Report to Planning and Environment Committee

To: Chair and Members
Planning and Environment Committee
From: Scott Mathers, MPA, P.Eng.
Deputy City Manager, Planning and Economic Development
Subject: 50 King Street London Limited (c/o York Developments)
50 King Street & 399 Ridout Street North
OZ-9622: Ward 13
Date: October 3, 2023

Image 18: Predicted Wind Conditions at Ground Level

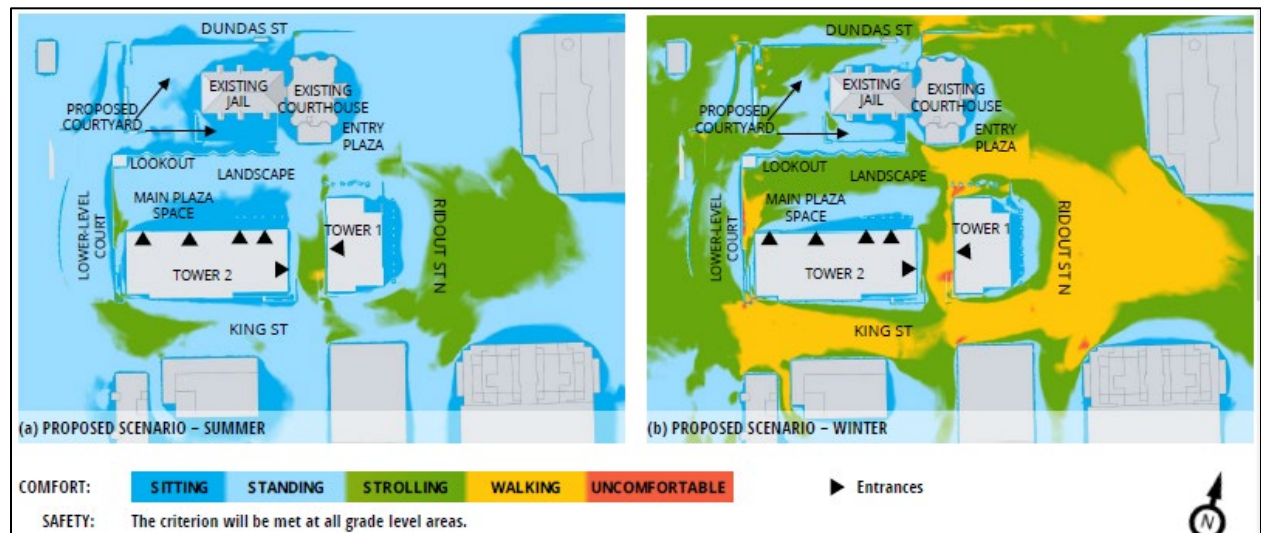
A wind Study was undertaken by RWDI to evaluate the potential wind impacts on the surrounding area as buildings that are taller than their surroundings tend to intercept and redirect wind around them. The study considered the long-term wind data that depicts the directional distributions of wind frequencies and speeds. The target conditions for wind speeds for pedestrian areas are wind speeds that are comfortable for walking or strolling,

and lower wind speeds for entrances or areas where people would be standing. Calm wind speeds are desired for areas where there are outdoor amenity areas and seating where there would be prolonged periods of passive activities. The proposed project is not expected to significantly alter wind conditions due to the stepped podium massing at the base and the orientation of the towers which moderate the impact of downwashing.

The wind-responsive design features moderate the impacts and the resulting conditions in the parks and public grounds to the north and west are not expected to be impacted negatively as wind speeds will continue to be similar to existing conditions. Wind speeds on most sidewalks and off-site areas are expected to be comfortable for standing or strolling in the summer, and for strolling or walking in the winter. Potentially uncomfortable wind speeds are expected: around the northwest corner of Tower 1; in a localized area under the building undercut along the western façade of Tower 1; the level 4 podium terrace; and the pool deck terraces at the top of Towers 1 & 2. Wind control strategies and design modifications such as tall planters, vertical screens or overhead trellises will be explored further to mitigate wind impacts through the future site plan approval process.

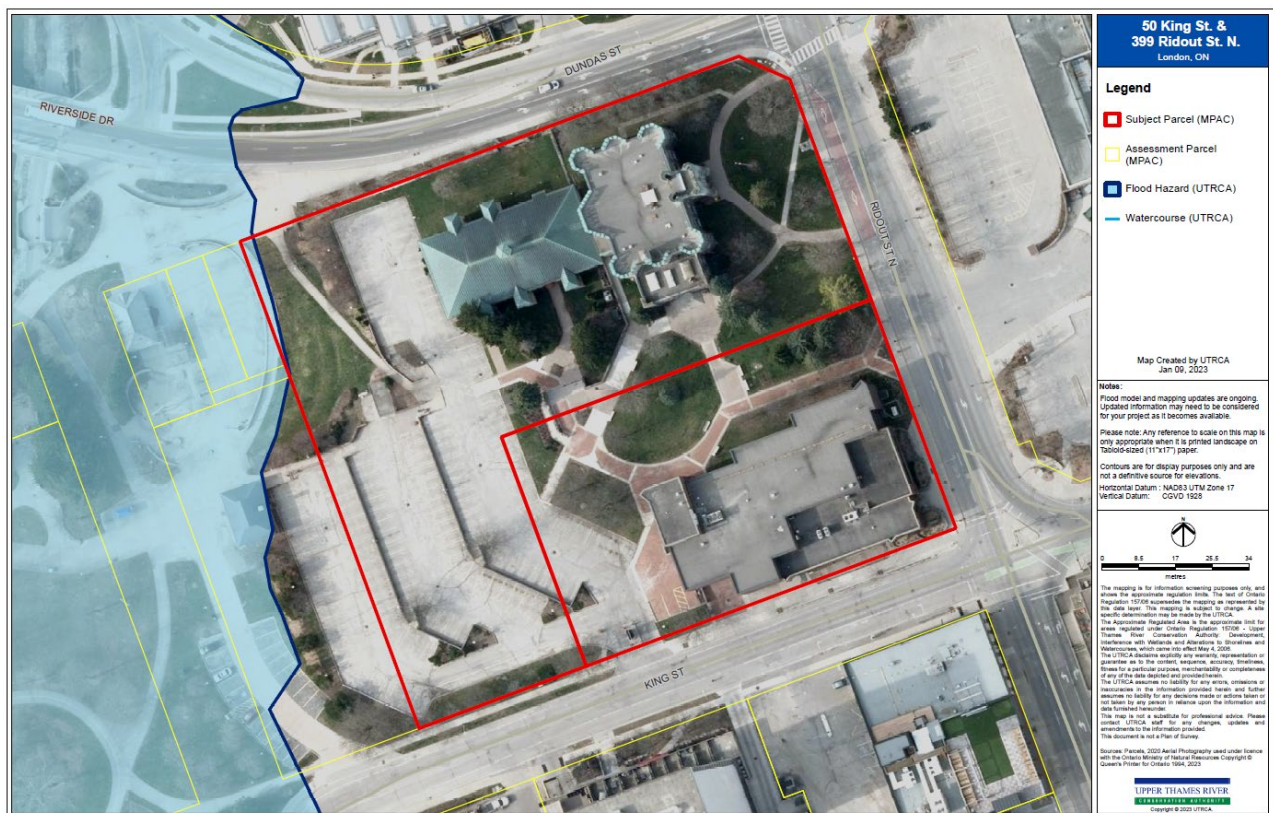
At the time of Site Plan Consultation (January 2023), the UTRCA requested that through the zoning amendment process, the applicant ensure that the Open Space OS4 zone is revised to reflect the updated floodplain of the North Thames River. The updated floodplain information was provided at this time. The applicant was advised to undertake a site specific topographic survey to delineate the extent of the floodplain (237.6 masl) and implement the appropriate Open Space zoning to reflect this. Further to the above, the UTRCA also requested the applicant ensure the regulatory flood elevation was delineated on all future plans/drawings. The above items are outstanding and have not been provided in the documentation submitted alongside this application.

Prior to providing a recommendation on this application, the UTRCA will require the applicant to provide the outstanding information to the satisfaction of the UTRCA, to ensure the Open Space OS4 zone accurately reflects the topography of the lands and the site specific hazard.

We remind the applicant that as the proposed development is located adjacent to the North Thames River, further information may be required to support the proposed underground parking garage. This information may include site specific structural

engineering to confirm that the underground parking garage can withstand the lateral hydrostatic pressures of the floodplain to an elevation of 237.6 masl.
